REMARKS

The present response cancels claims 3, 4, 11, and 17 without prejudice or disclaimer as to the subject matter recited therein. In addition, the specification and claims 1, 5, 10, 12-14, 16, and 18-20 have been amended. Claims 1, 2, 5-10, 12-16, and 18-20 remain pending in the captioned case. Further examination and reconsideration of the presently claimed application are respectfully requested.

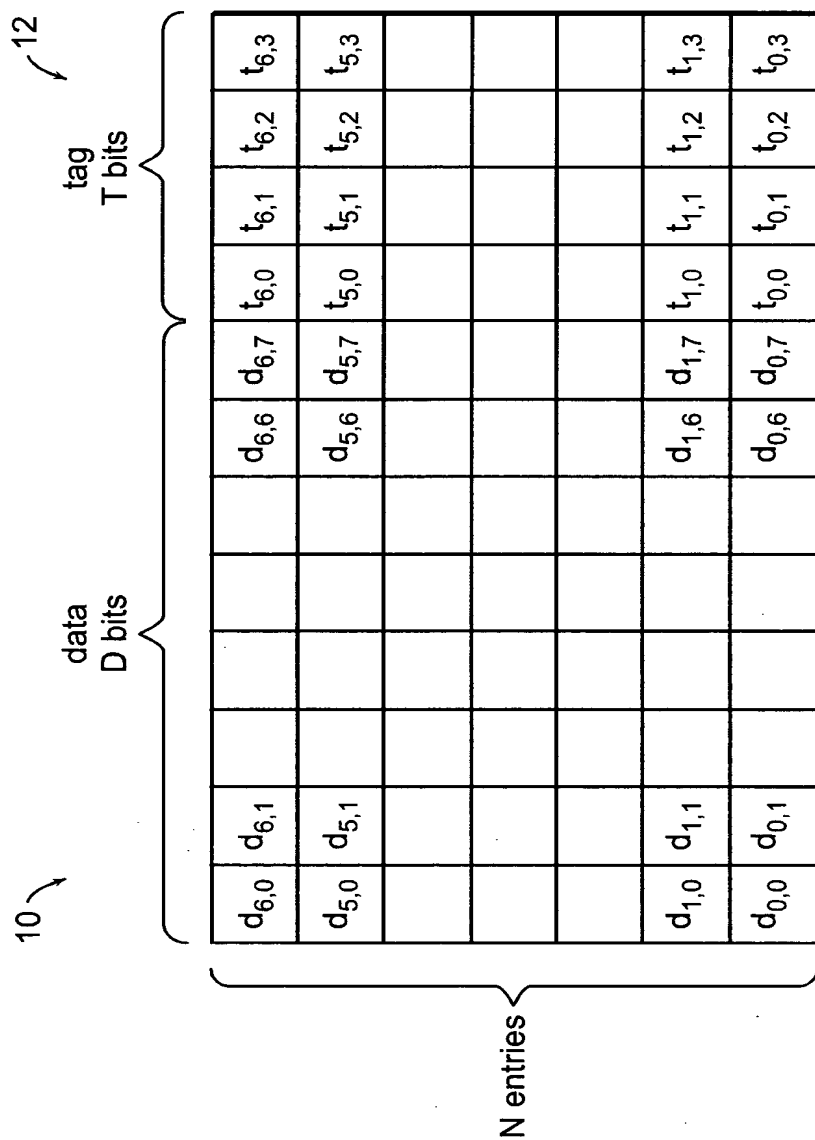
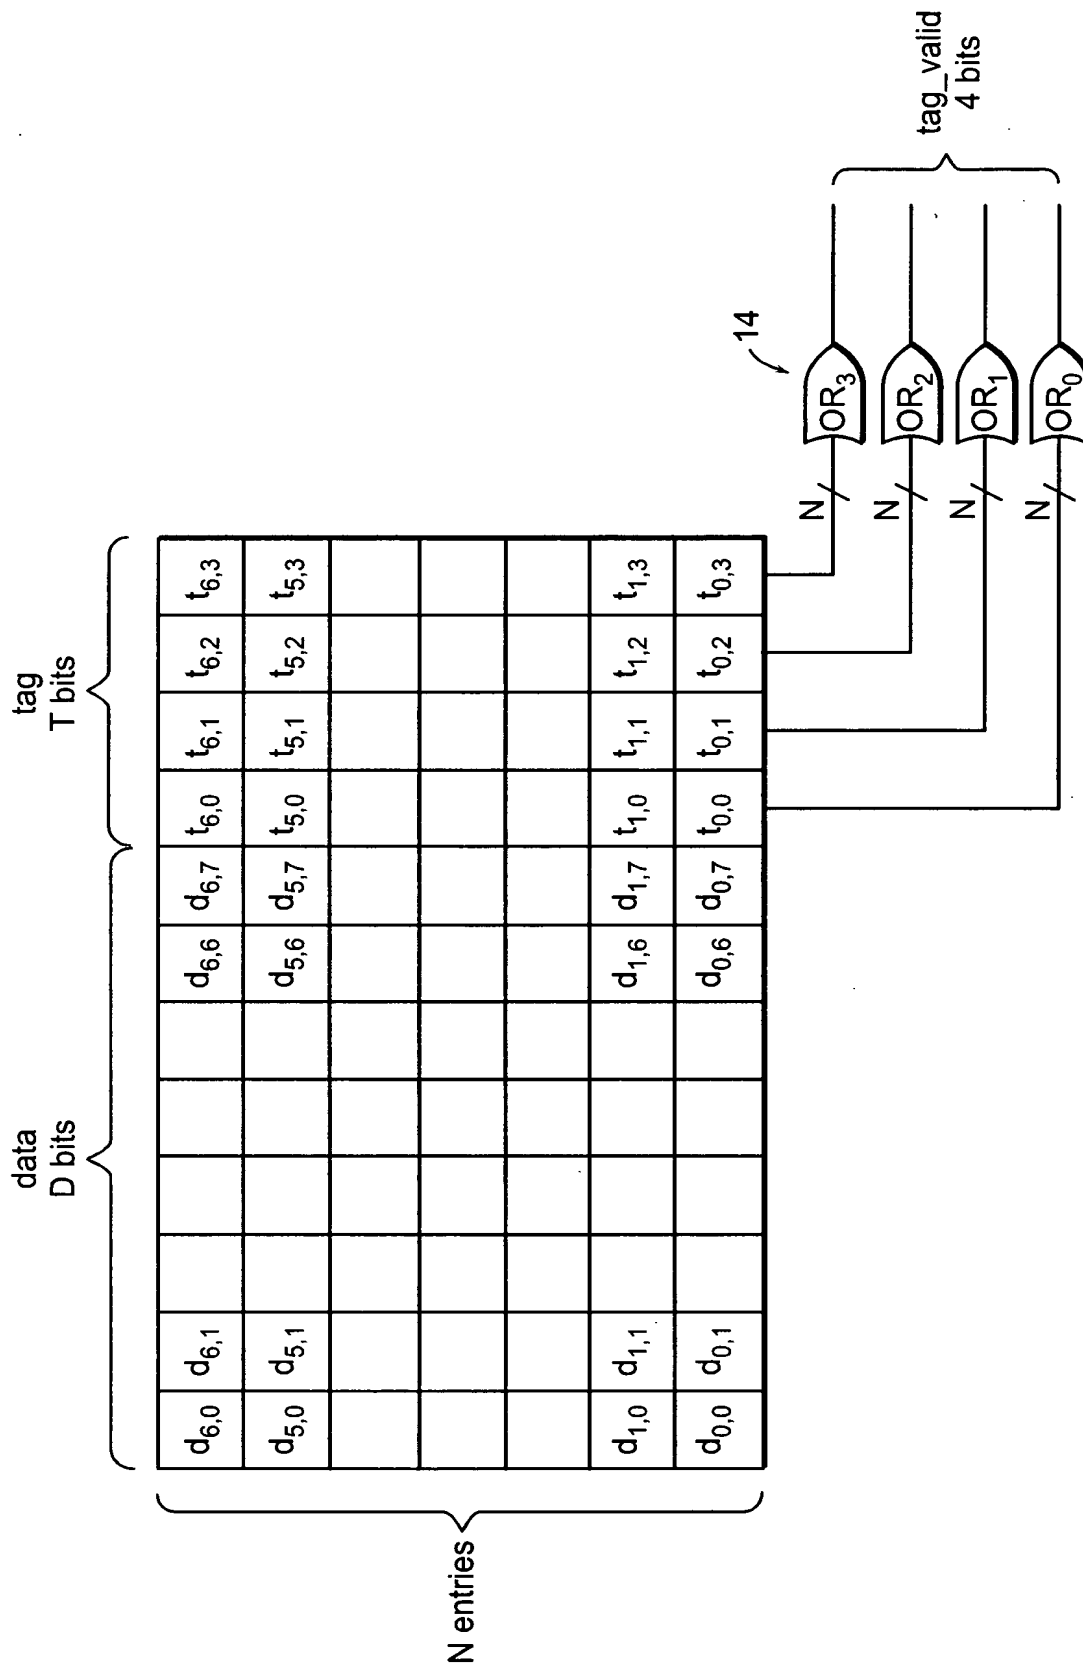
Objections were lodged against the drawings for various reasons. For example, Figs. 1a and 1b were objected to as not containing the term "Prior Art." In citing MPEP § 608.02(g), the Office Action alleges that Figs. 1a and 1b only show that which is old. Applicant disagrees. While Applicant admits that a storage location within a FIFO can contain both data bits and tag bits, Fig. 1a indicates a specific number of tag bits, for example, and Fig. 1b indicates the values within certain tag bit locations can be compared within an exclusive OR gate 14 (Drawings -- Figs 1a and 1b). Nowhere is there any suggestion in the "Background" section of the specification or otherwise that the illustrated number of tag bits and the combination of tag bits using a logic gate is/are deemed prior art. The only reference to "typical" is in the "Brief Description" portion of the specification when referencing a storage device, such as a FIFO buffer. Applicant does not deny that a FIFO is a typical storage device, but otherwise respectfully traverse any suggestion that Figs. 1a and 1b should be designated as "Prior Art." If, however, the Examiner can find a drawing in a prior art reference identical to that of Figs. 1a and 1b, then Applicant

will designate the drawings as "Prior Art." With regard to Fig. 2, formal drawings are submitted herewith to obviate this objection.
